## **Port Kembla Gas Terminal — Modification 1 Response to Department of Primary Industries Fisheries**

The below table provides responses to the issues raised in the submission received from Department of Primary Industries Fisheries (C19/696) on the proposed modification of Port Kembla Gas Terminal.

FSRU plan view showing location of seawater intakes

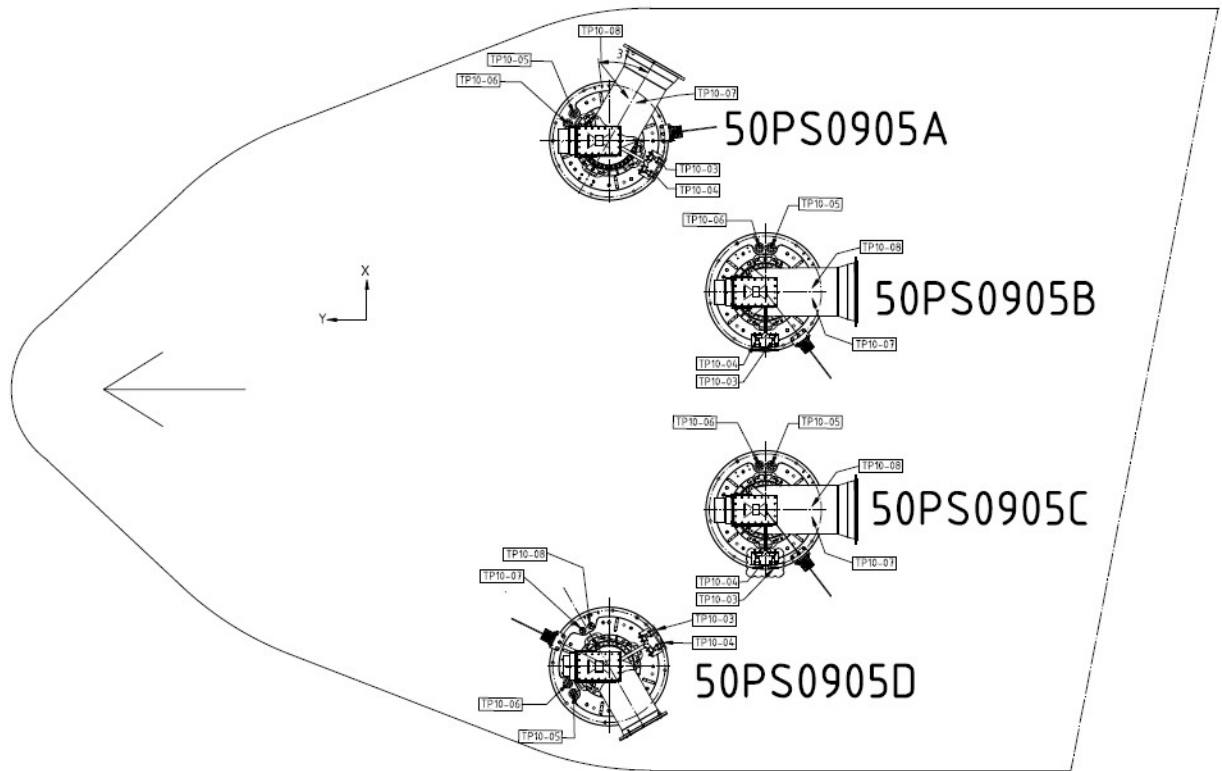
| Issue   | Response  |
|---|---|
| <p><u>Design of intake structure</u></p> <p>The submission requests Department of Primary Industries Fisheries be consulted concerning the design of the water intake structure.</p>  | <p>Design information for the water intake structures and strainers is provided in Attachment A.</p>  |
